A d d e n d u m

Iowa Department of Transportation
Office of Contracts

B.O.	Proposal ID	Proposal Work Type	County	Project Number	Addendum
501	57-1001-081	CLEARING & GRUBBING	LINN	NHSN-100-1(81)--2R-57	19NOV501.A01

TREE FELLING
NHSN-100-1(81)-2R-57

ENGLISH	2013\1\1\DOT	Jweh	DESIGN TEAM	Iowa DOT\CH2MHILL	LINN COUNTY	PROJECT NUMBER	NHSN-100-1(81)-2R-57	SHEET NUMBER	D-4
---------	--------------	------	-------------	-------------------	-------------	----------------	----------------------	--------------	-----

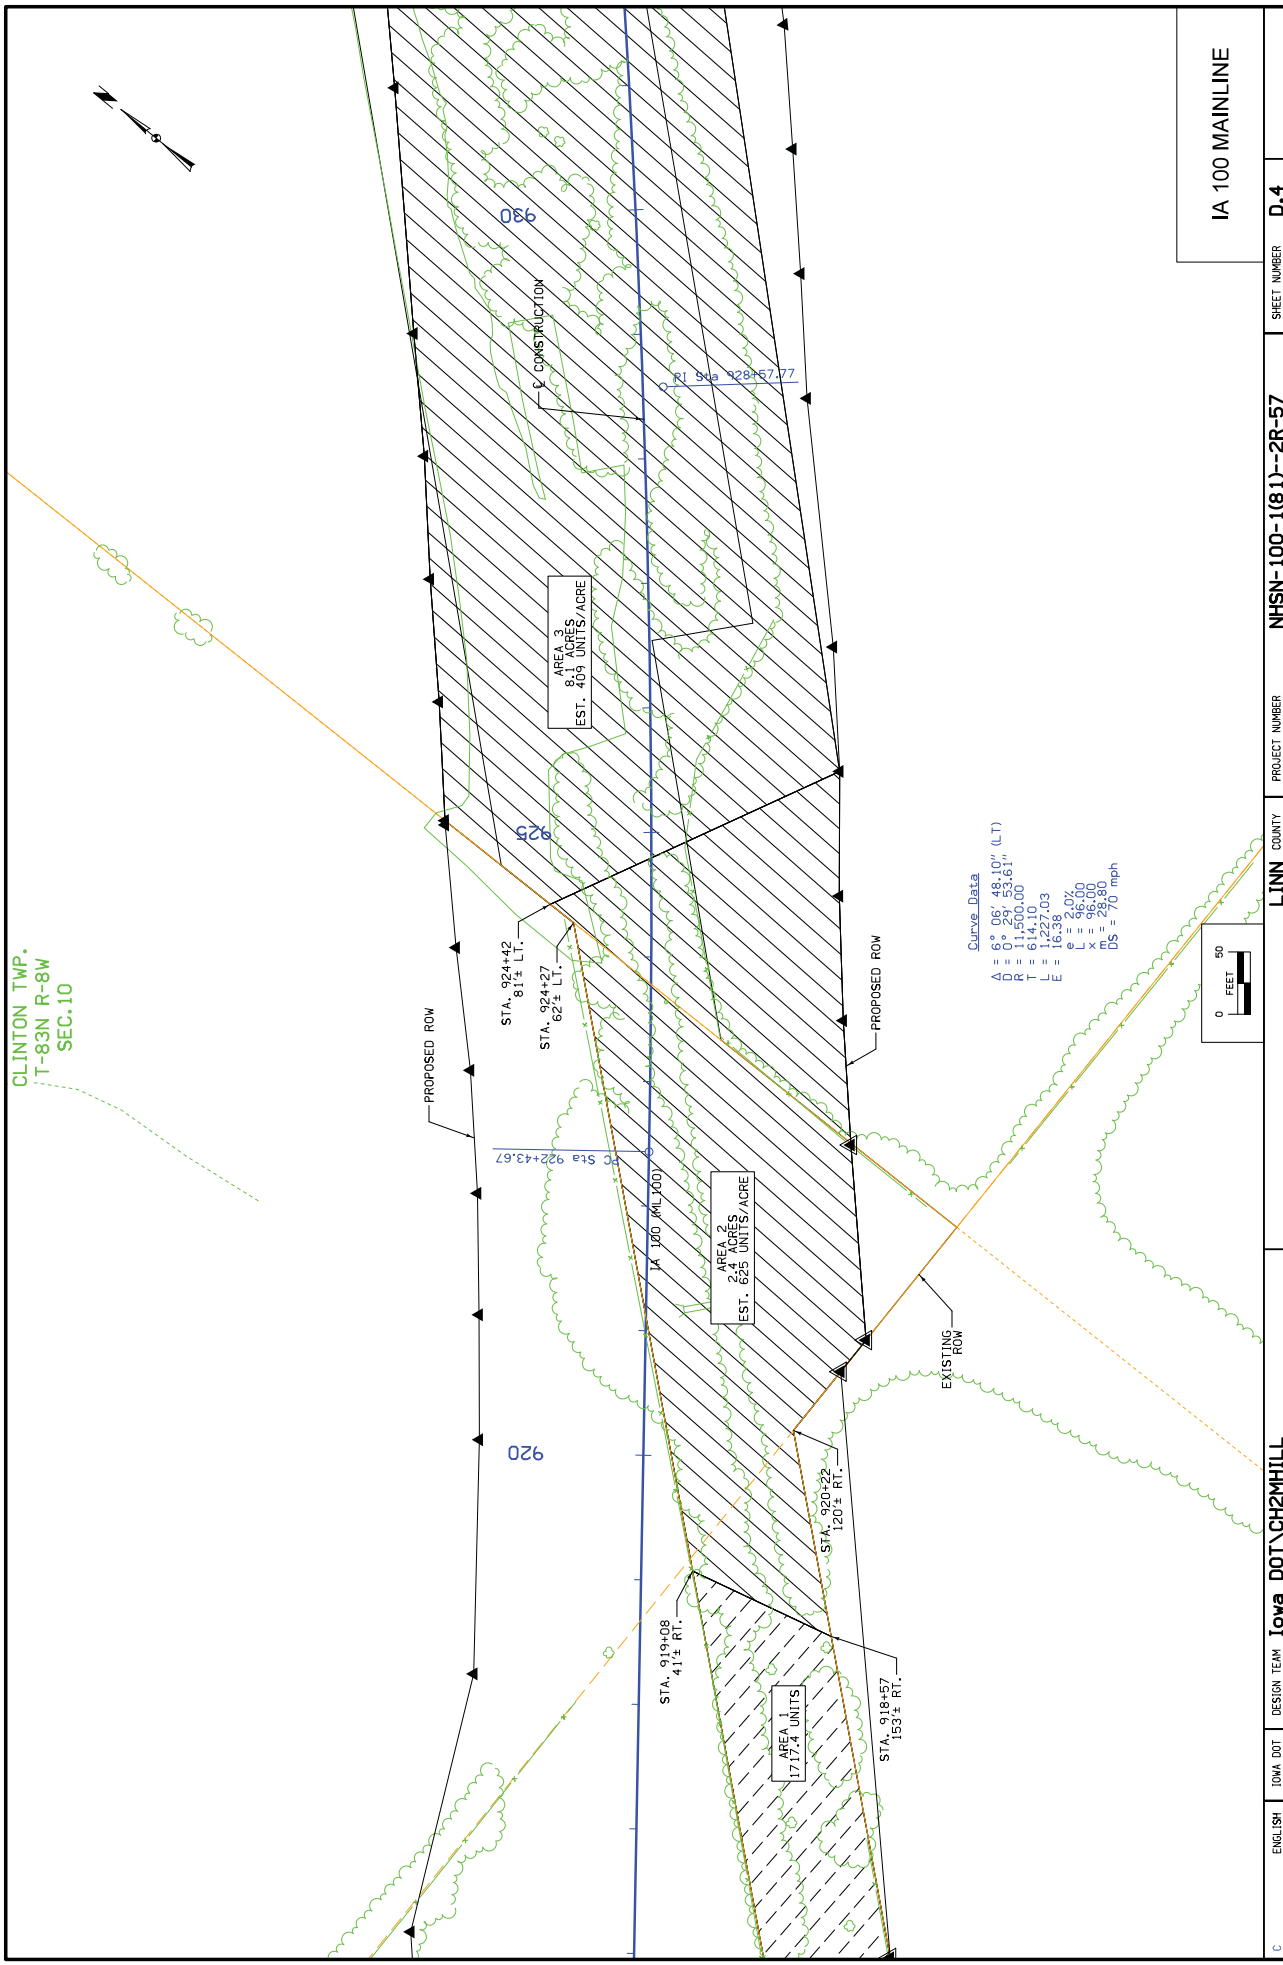
Replace Sheet D.4 with the attached Sheet D.4.

Updated Area 2 limits, quantity note, and associated callouts

Updated Area 3 limits, quantity note, and associated callouts

ENGLISH	2013\1\1\DOT	Jwan1	DESIGN TEAM	Iowa DOT\CH2MHILL	PROJECT NUMBER	NHSN-100-(81)-2R-57	SHEET NUMBER	D.5
IA 100 MAINLINE

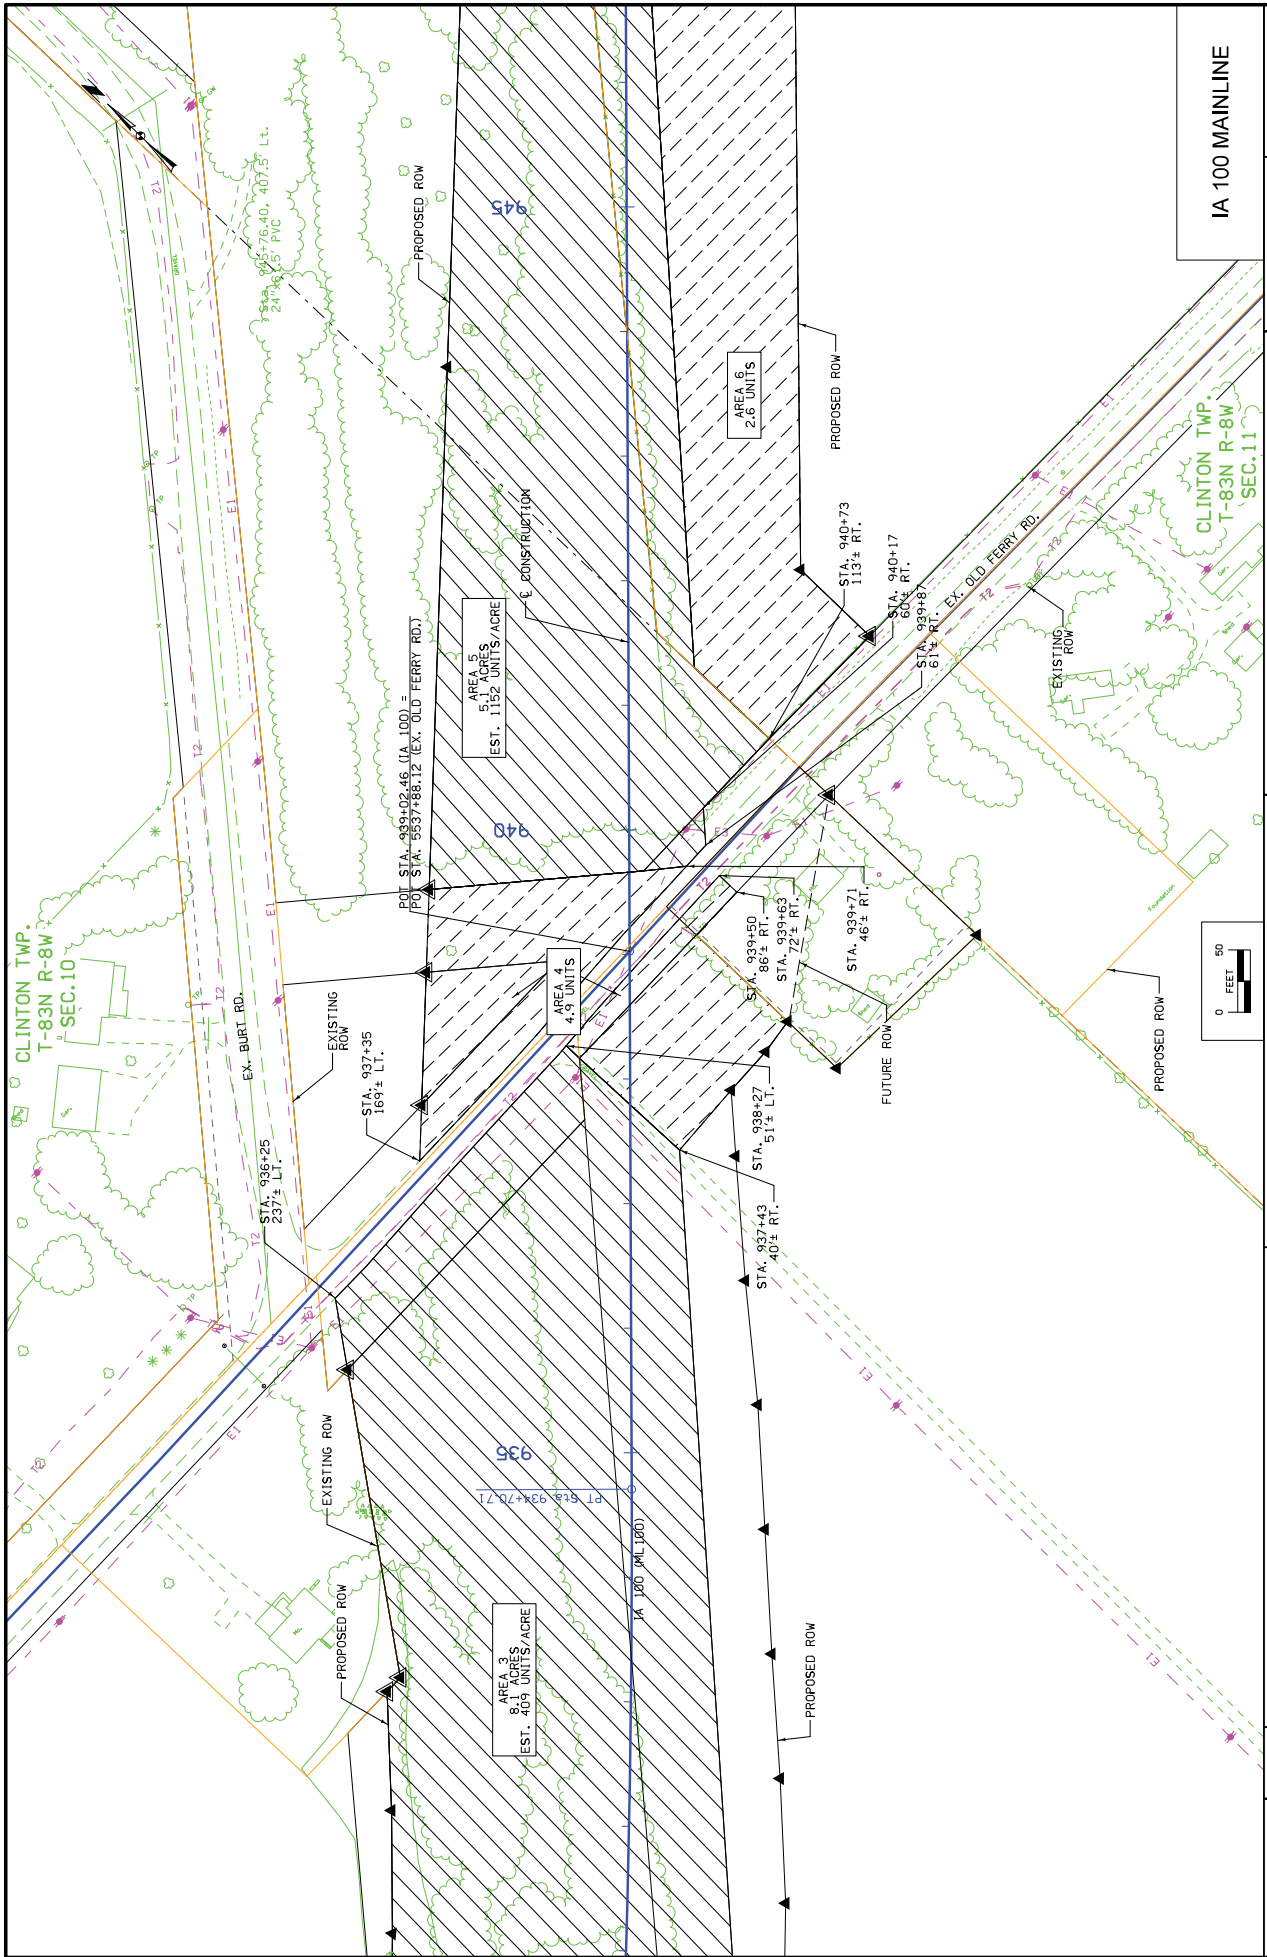
Replace Sheet D.5 with the attached Sheet D.5.

Updated Area 3 limits, quantity note, and associated callouts

Updated Area 4 limits and associated callouts

Updated Area 5 limits, quantity note, and associated callouts

Added Area 6 limits, quantity note, and associated callouts

ENGLISH	2013\11\01	Jwan1	DESIGN TEAM	Iowa DOT\CH2MHILL	PROJECT NUMBER	NHSN-100-1(81)-2R-57	SHEET NUMBER	D.6
<p>1:35:12 PM</p> <p>cr:\pwworking\ch2mhill\lrbg\jwan\dot79931\57\0008\001.sht</p>

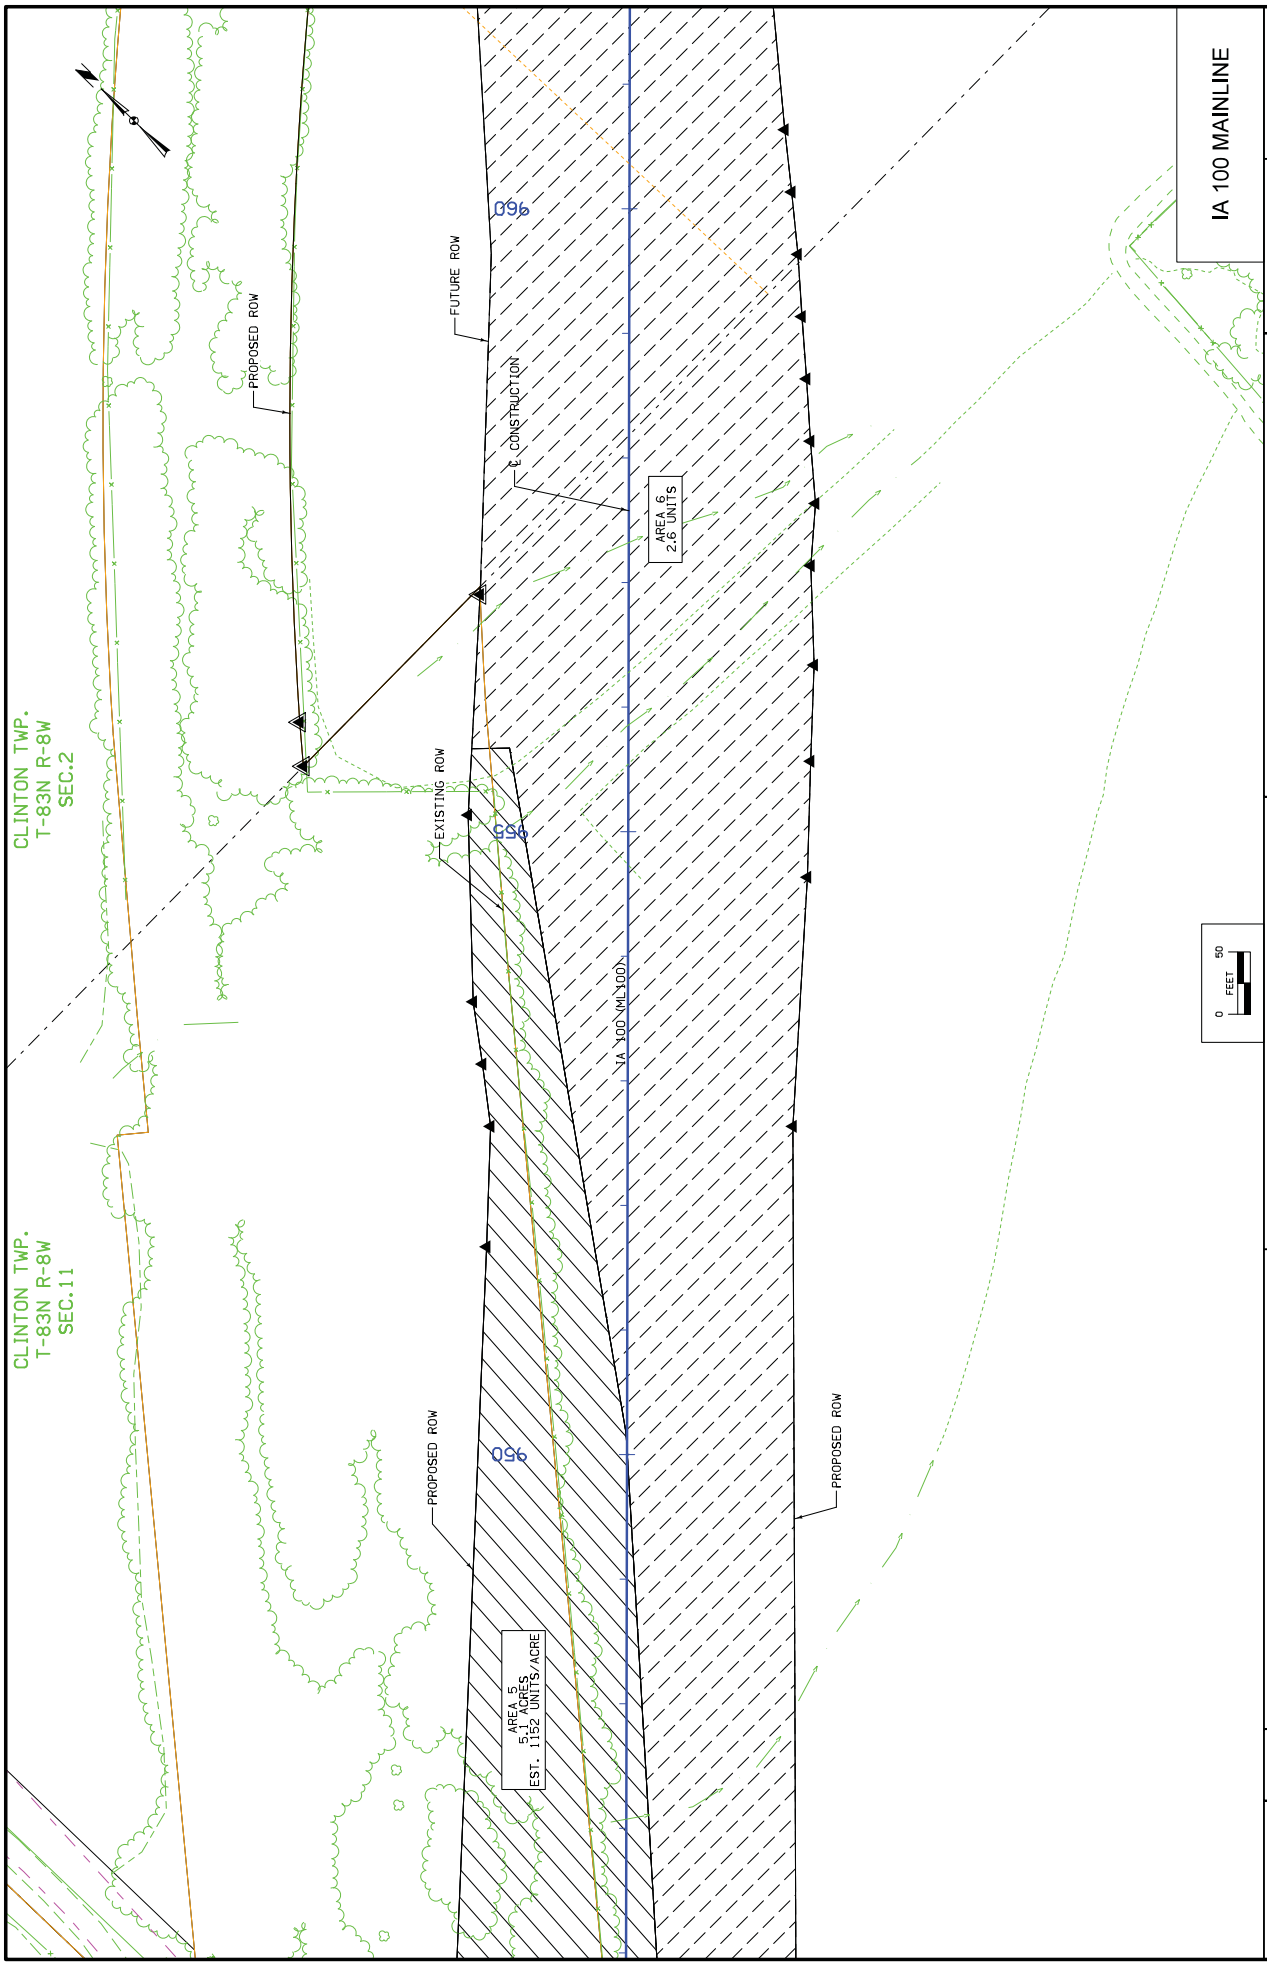
Replace Sheet D.6 with the attached Sheet D.6.

Updated Area 5 limits, quantity note, and associated callouts

Added Area 6 limits, quantity note, and associated callouts

ENGLISH	DATE	DESIGN TEAM	Iowa DOT\CH2MHILL	PROJECT NUMBER	NHSN-100-1(81)-2R-57	SHEET NUMBER	D.7
2013\11\01	Jwan			LINN COUNTY			
			CLINTON TWP. T-83N R-8W SEC.11	IA 100 MAINLINE

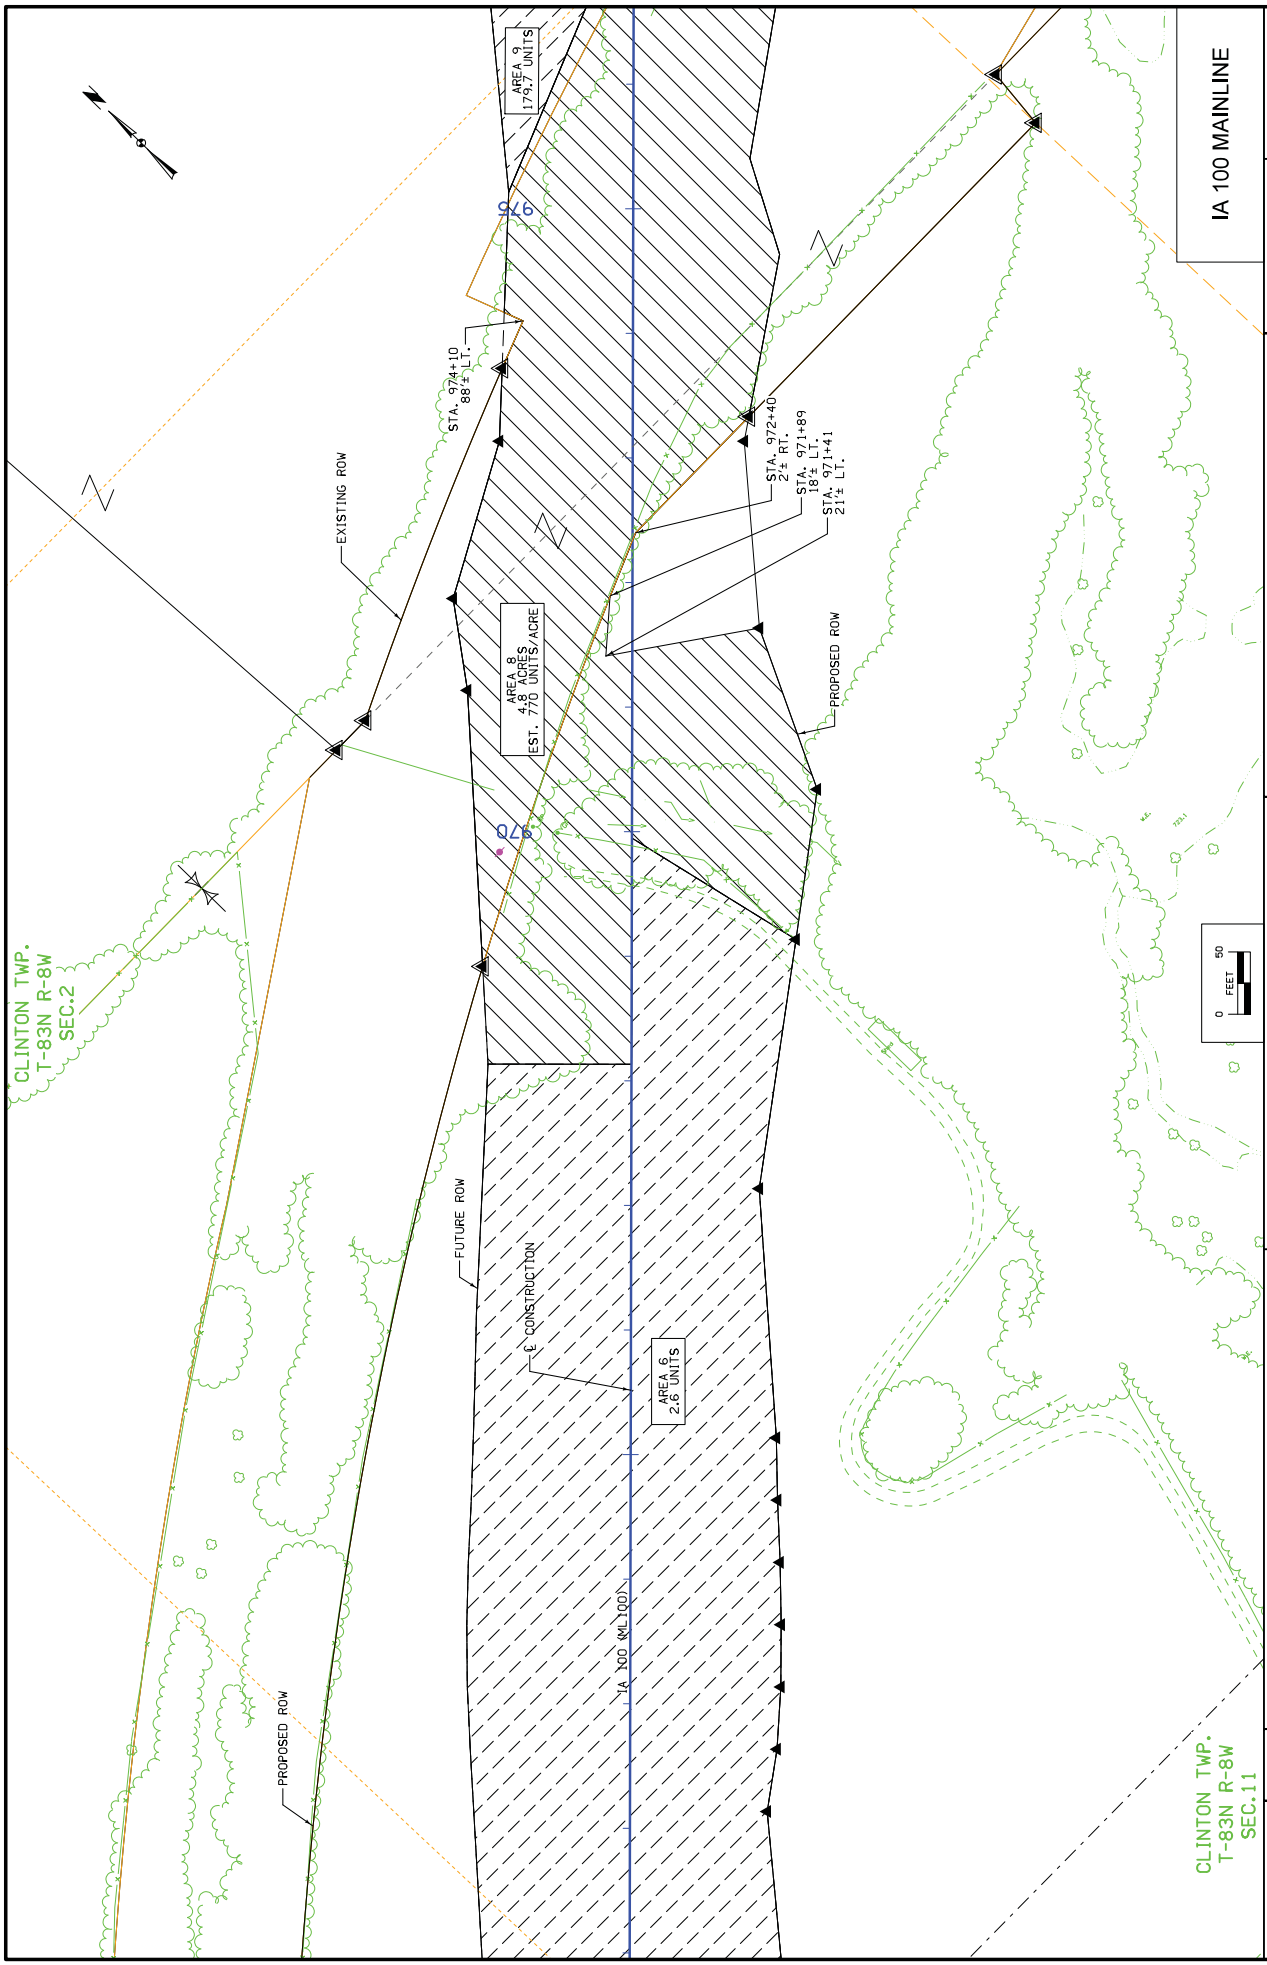
Replace Sheet D.7 with the attached Sheet D.7.

Added Area 6 limits, quantity note, and associated callouts

Updated Area 8 limits, quantity note, and associated callouts

Added Area 9 limits, quantity note, and associated callouts
